Explanation of Significant Difference for the Revision 1 Record of Decision Remedial Alternative Selection for the Wetland Area at Dunbarton Bay in Support of Steel Creek Integrator Operable Unit (U)

SRNS-RP-2022-00982

Revision 1

April 2023

Figure 2. WADB Project Area (Showing Previous Land Use Control Boundary)

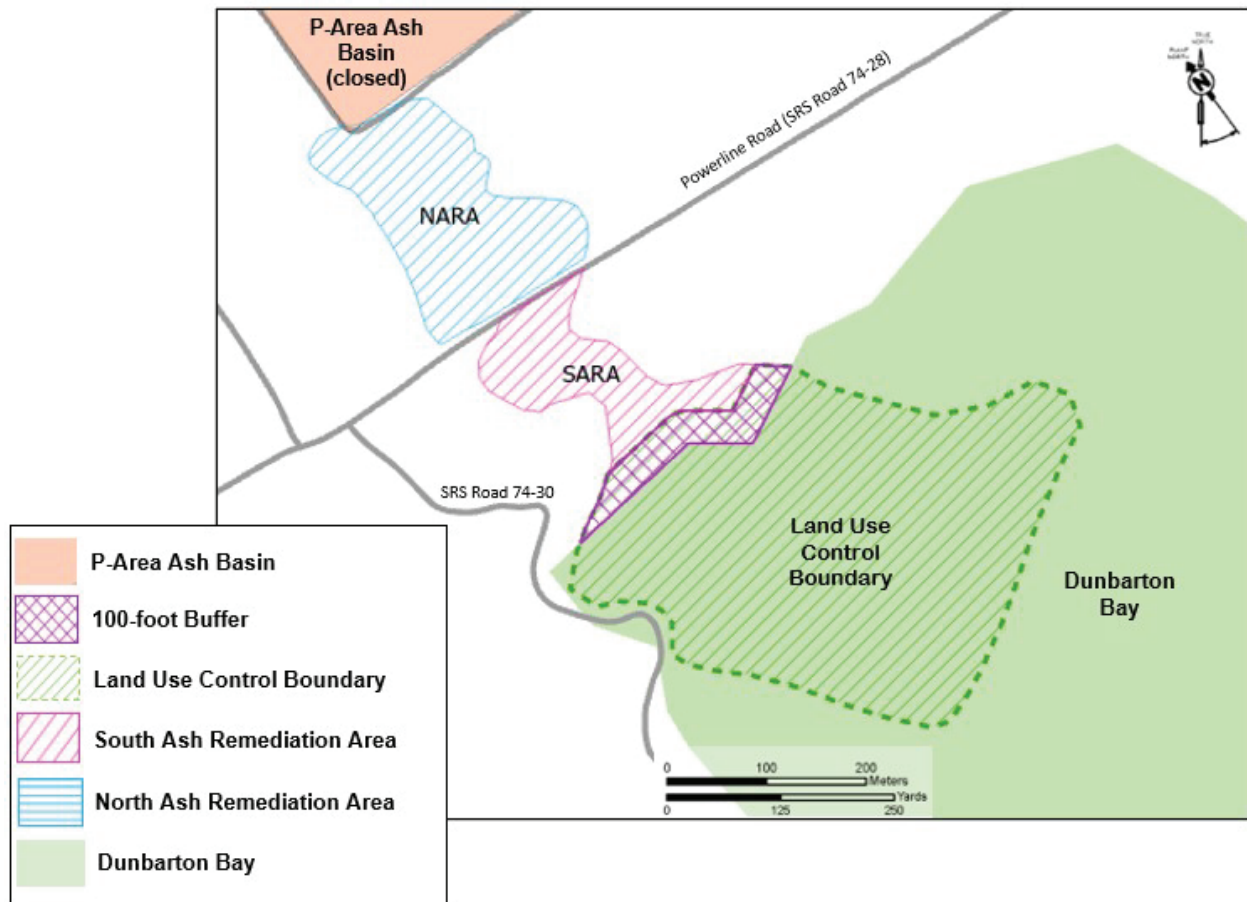
The ROD for the WADB (SRNS 2018a) employed LUCs for 10 ha (25 ac) since the entire volume of waste was not to be excavated and some material would be left in place. The initial LUC boundary is shown in Figure 2. The purpose of this ESD is to document expanded LUCs that include the SARA, the additional ash discovered outside of the SARA, as well as the initial LUC boundary protective of and within the Dunbarton Bay.

Figure 3. Location of Additional Ash, Existing Sign Locations, and Existing Land Use Control Boundary

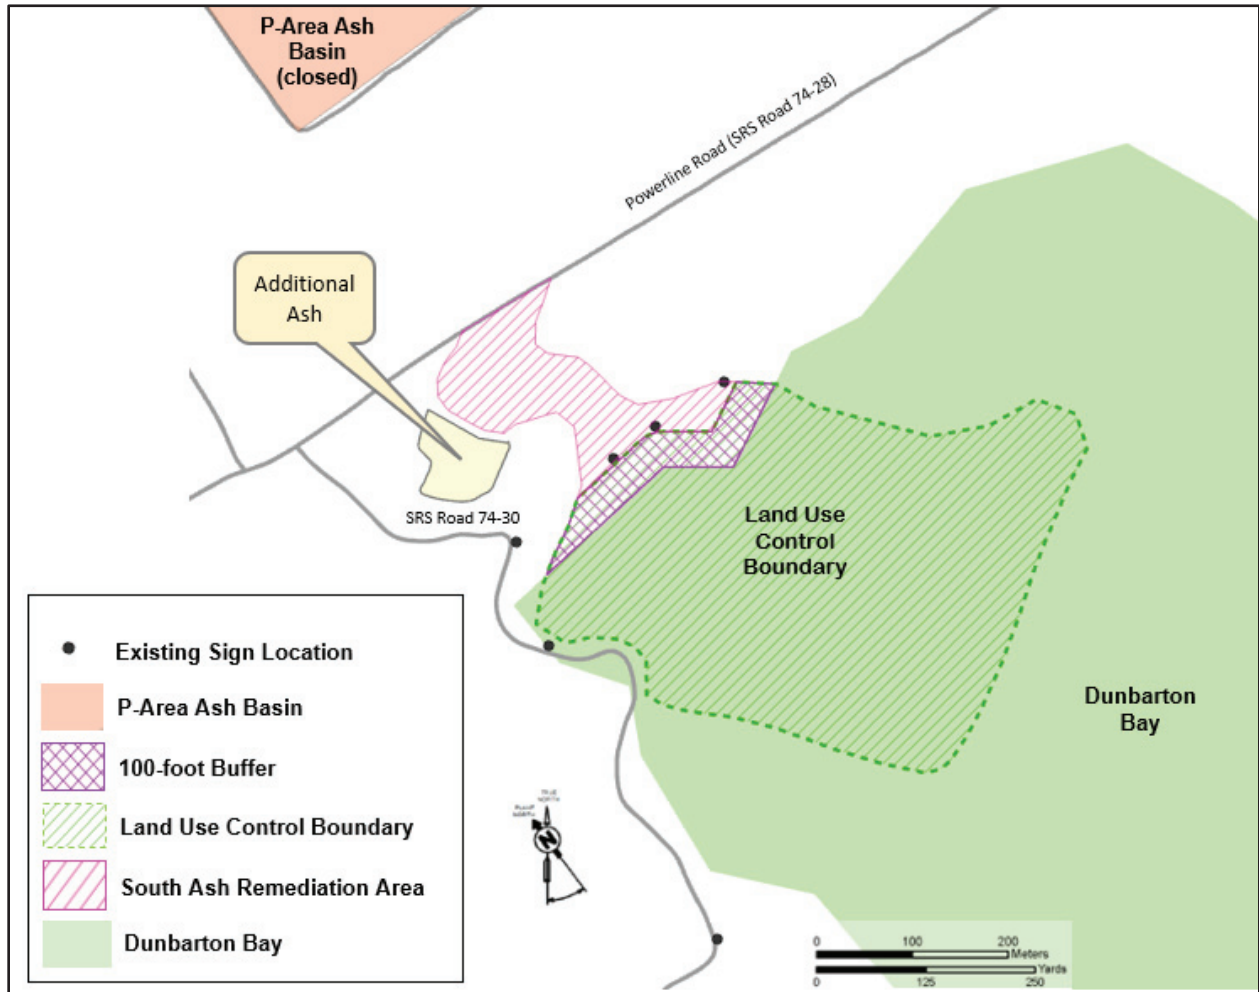
The ROD for the WADB was issued June 20, 2018 (SRNS 2018a). The significant difference described in this ESD is to expand the LUC boundary to include the SARA and additional ash to the east of the SARA. Expansion of the LUC boundary will be protective of human health and the environment without additional excavation and disposal of the ash. The additional ash is located between Powerline Road and Dunbarton Bay (Figure 3).

The actions described herein are documenting an expanded LUC boundary for the WADB from Powerline Road to the 30-m (100-ft) buffer along the northern edge of Dunbarton Bay. The LUC boundary maintains the previously designated LUC area within the 30-m (100-ft) buffer and within Dunbarton Bay (Figure 3). The entirety of the expanded LUC boundary consists of ~16 ha (~39 ac) (Figure 4). The expanded LUCs are estimated to cost approximately \$50,000. It is estimated that pursuing continued excavation and offsite disposal of the SARA and additional ash would cost approximately \$5.8 Million due to the saturated field conditions along with an escalation factor from 2019 to 2023 dollars. This additional cost would result in a total remedial cost for the WADB that exceeds the ROD estimate.

Figure 4. Expanded Area Subject to Land Use Controls

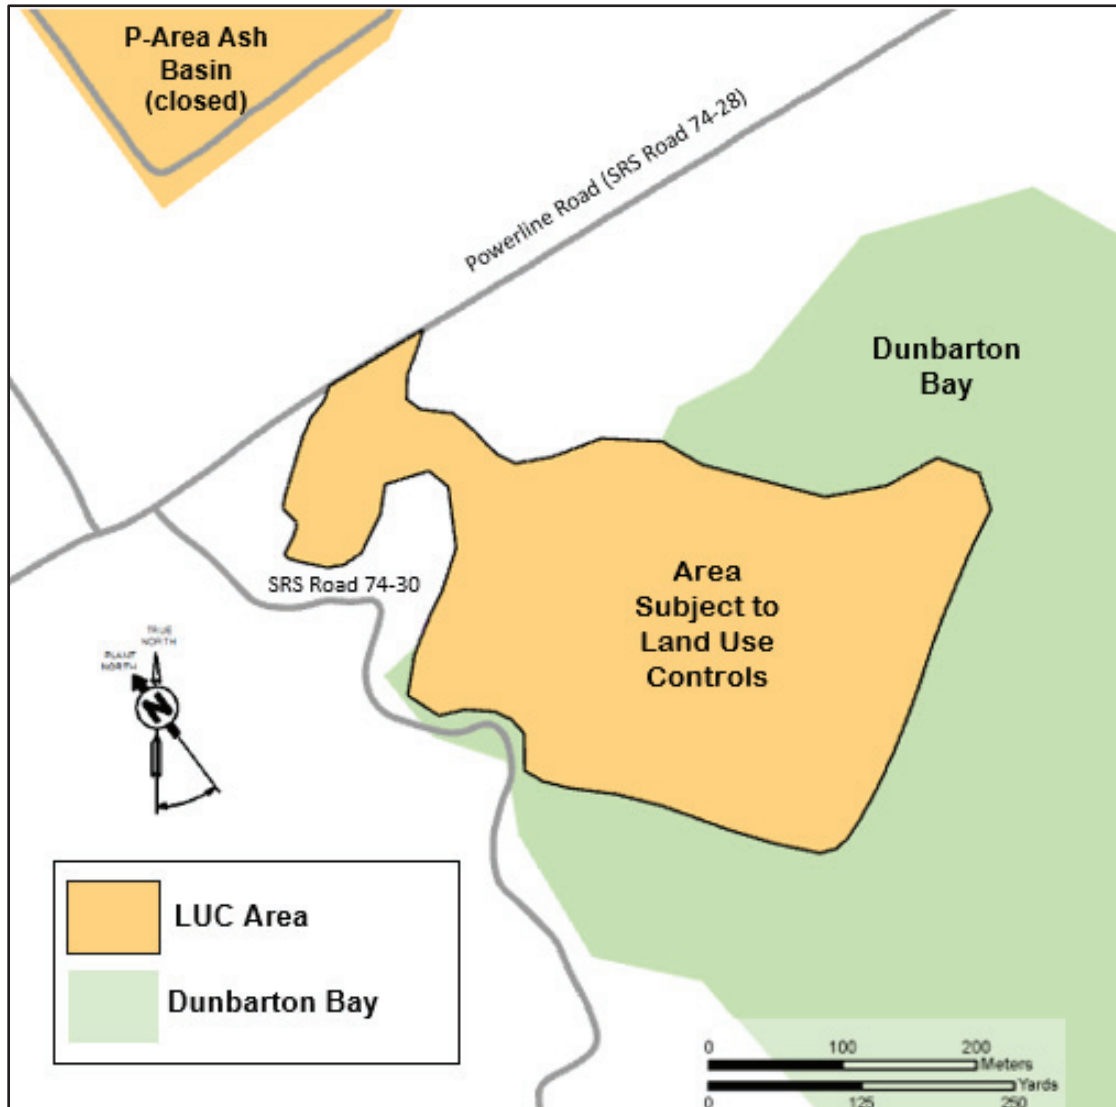
The remedial action addressed in this ESD requires an expanded LUC boundary for the WADB beyond the initial LUC area established for Dunbarton Bay. The expanded LUCs are being implemented to include the ash deposits remaining in the SARA and the additional ash discovered outside of the boundary of the SARA

(Figure 4). LUCs include both institutional controls (i.e., excavation permit restrictions, deed restrictions, health and safety plans for entry, etc.) and physical access controls (i.e., physical barriers, warning signs, no trespassing signs, access controls, and/or fencing, etc.) to minimize the potential for human exposure to contaminants by limiting land access or resource use.
